RE: 4736878 - Tri Pointe Homes

Project Customer: Tri Pointe Homes    Project Name:  
Lot/Block: 347    Subdivision: SERENITY  
Address: 67 SHADY CREEK WAY  
City: FUQUAY-VARINA    State: NC

This package includes 4 individual, dated Truss Design Drawings and 0 Additional Drawings.

No.	Seal#	Job ID#	Truss Name	Date
1	I75325404	4736878	B01	8/1/25
2	I75325405	4736878	C01	8/1/25
3	I75325406	4736878	D01	8/1/25
4	I75325407	4736878	J06	8/1/25

Job 4736878	Truss C01	Truss Type Piggyback Base	Qty 9	Ply 1	Tri Pointe Homes Job Reference (optional)	I75325405
----------------	--------------	------------------------------	----------	----------	--	-----------

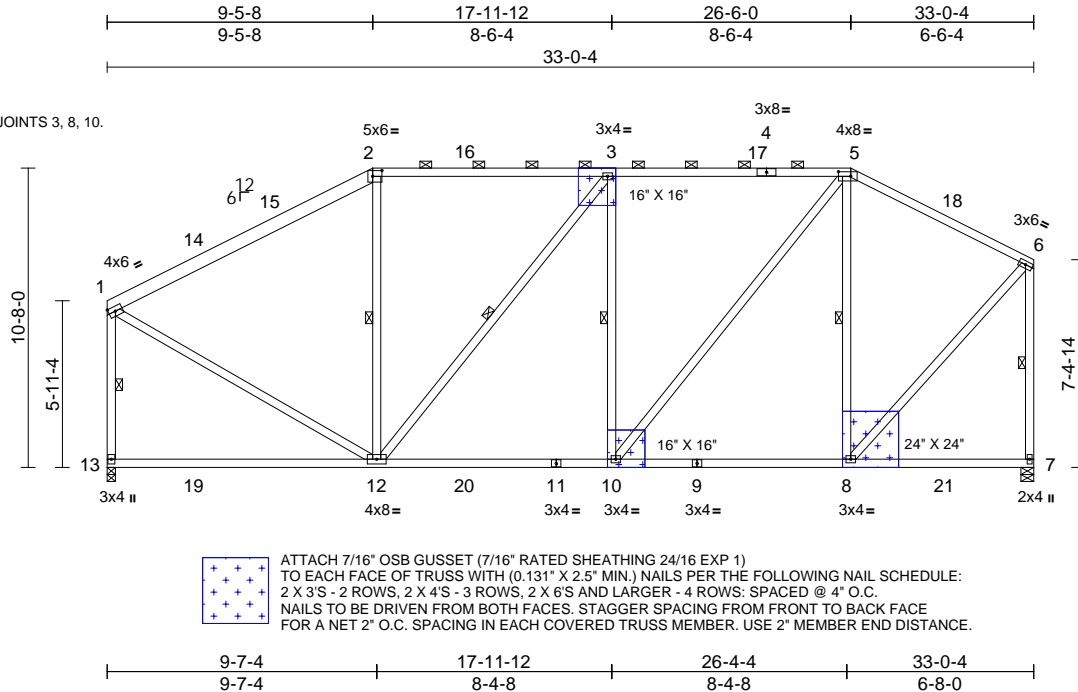
MISPLACED PLATES AT JOINTS 3, 8, 10.

Job	Truss	Truss Type	Qty	Ply	Tri Pointe Homes	I75325406
4736878	D01	Piggyback Base	3	1	Job Reference (optional)

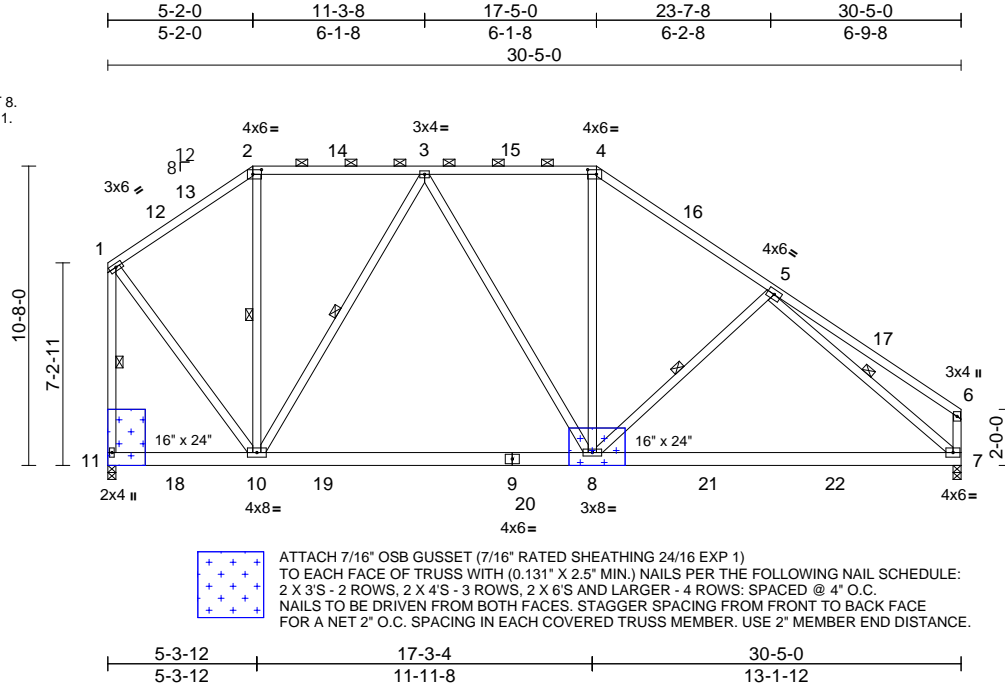
MISPLACED PLATE AT JOINT 8.  
MISSING PLATES AT JOINT 11.

ATTACH 7/16\" OSB GUSSET (7/16\" RATED SHEATHING 24/16 EXP 1)  
TO EACH FACE OF TRUSS WITH (0.131\" X 2.5\" MIN.) NAILS PER THE FOLLOWING SCHEDULE:  
2 X 3'S - 2 ROWS, 2 X 4'S - 3 ROWS, 2 X 6'S AND LARGER - 4 ROWS: SPACED @ 4\" O.C.  
NAILS TO BE DRIVEN FROM BOTH FACES. STAGGER SPACING FROM FRONT TO BACK FACE  
FOR A NET 2\" O.C. SPACING IN EACH COVERED TRUSS MEMBER. USE 2\" MEMBER END DISTANCE.
